Docket Number:	17-AAER-06
Project Title:	Commercial and Industrial Fans & Blowers
TN #:	224132
Document Title:	AHRI presentation
Description:	N/A
Filer:	System
Organization:	AHRI
Submitter Role:	Public
Submission Date:	7/12/2018 8:55:03 AM
Docketed Date:	7/12/2018

AHRI presentation

AHRI presentation in response to commercial and industrial fans and blowers proposed regulation and staff report.

*California Energy Commission Staff
Workshop – Commercial and Industrial Fans
and Blowers, Docket 17-AAER-06*

The FEI Paradox

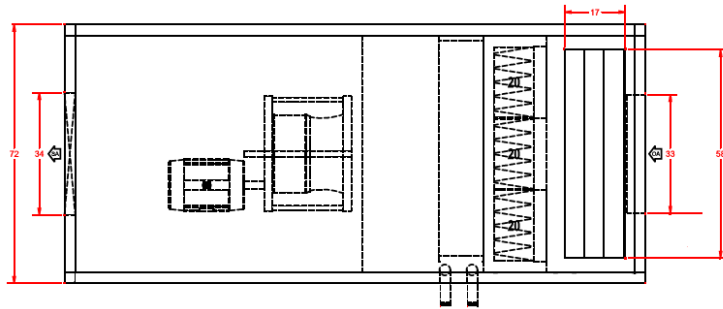
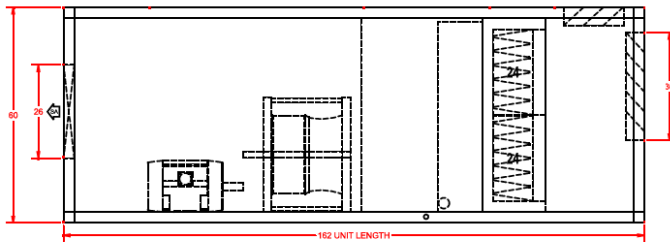
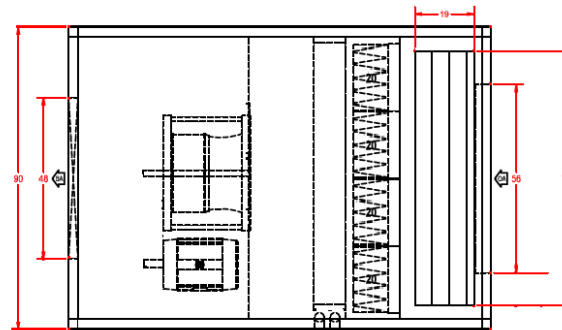
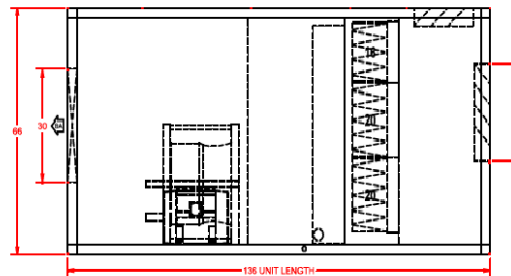
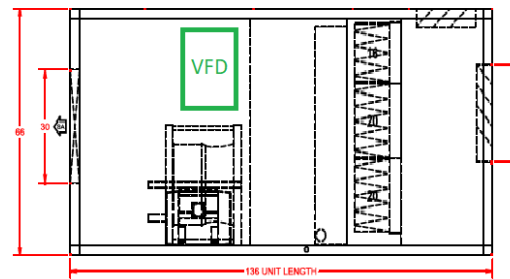
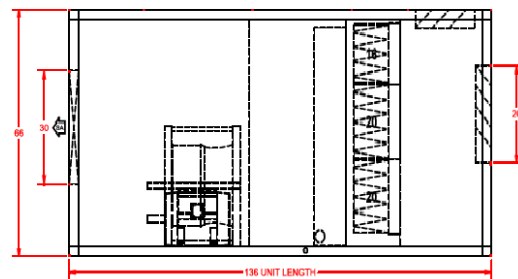
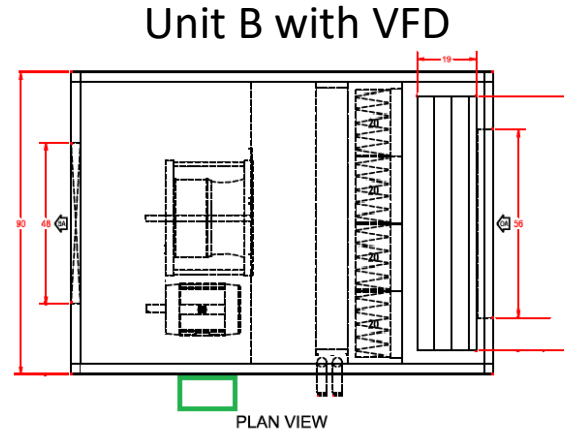
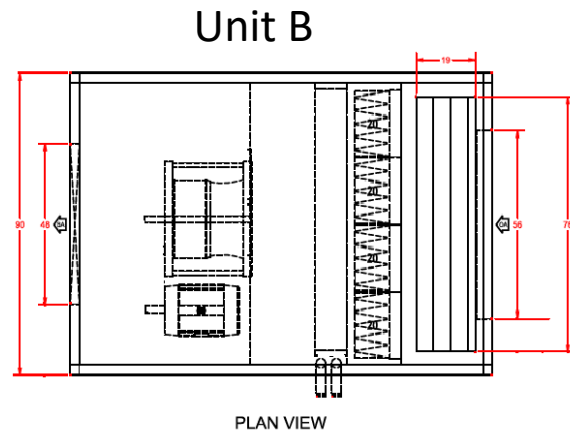
Lower AHU power consumption yields lower FEI

Two air handlers, with identical fans, motors and transmissions

Each has identical performance except for the fan brake horsepower at the design point:

- 12,000 SCFM
- 80°F db / 67°F db mixed air entering the coil
- 53°F db / 52.9°F db leaving the coil
- MERV-8 pre-filter
- MERV-13 high-efficiency filter
- 24.5" v-belt drive plenum fan
- 15 HP NEMA General Purpose Motor
- Rated with 1.0" external static pressure

The difference: Unit B has:

- A larger cabinet
- Larger coil and filter face areas
- Larger entrance and exit openings
